The January 28, 2011 Transit review of BERP V-I is based on implied dimensions from measurements taken of the graphics within the CAD files provided to CRC dated January 4, 2011.

Final Dimensions to be verified in Detail Design.																	
Project: COLUMBIA RIVER CROSSING																	
Title of Drawing: OPTION 1 CABLE STAY

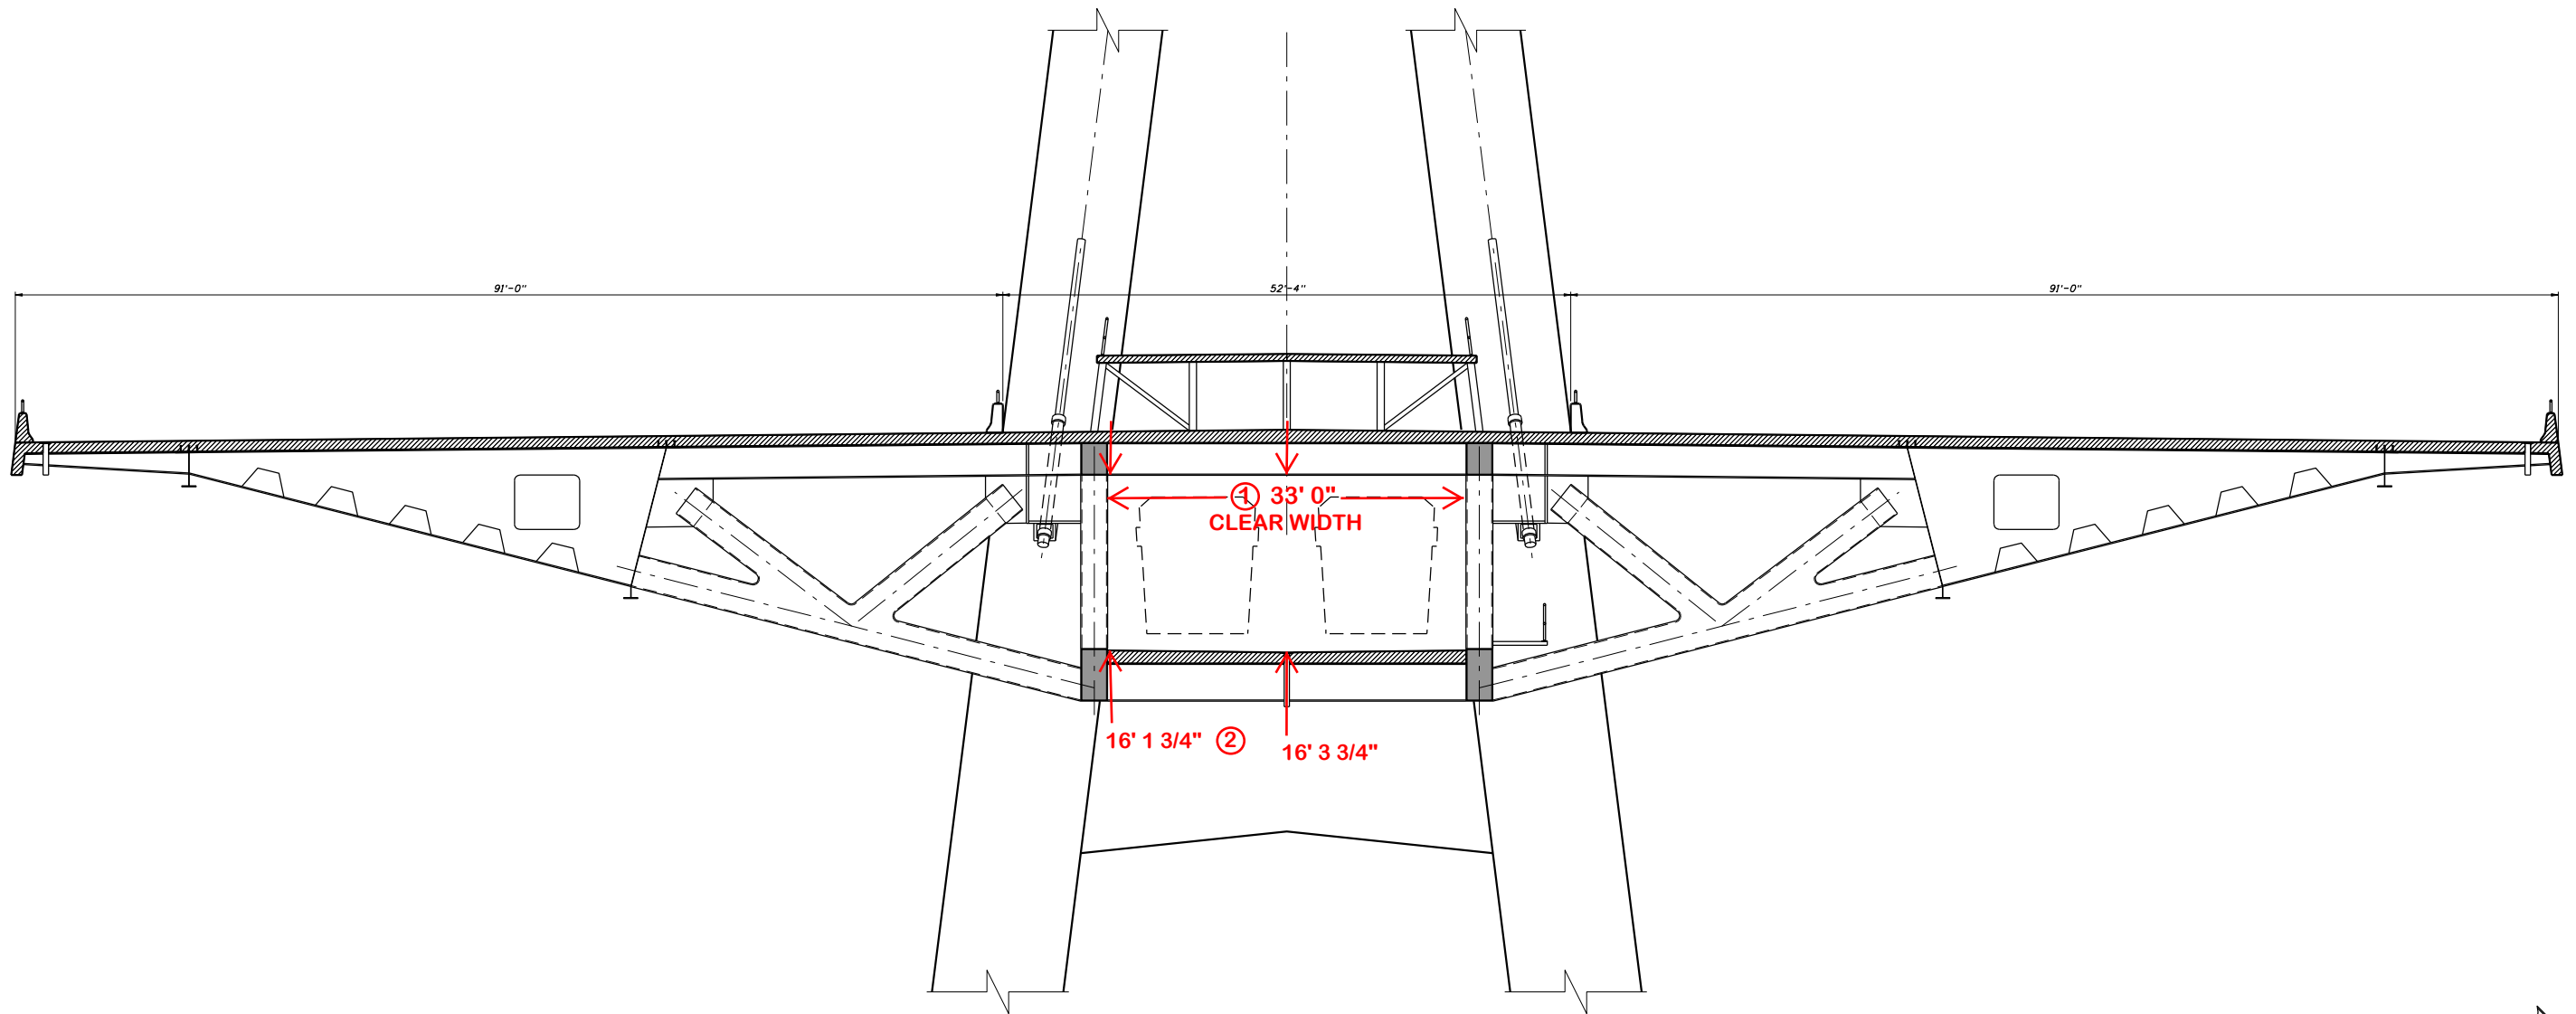
1. Apparent clear width of 33'-0" must be preserved. Any structural or non-structural bridge related appurtenances must exist outside the 33'-0" clear zone throughout the entire length of the river crossing.
2. Vertical clearance does not appear adequate. 16'-6" is the absolute minimum height acceptable for the combination of vertical clearance from top of rail to OCS wires (14'), OCS attachments (1'), rail and fasteners (1'-6").
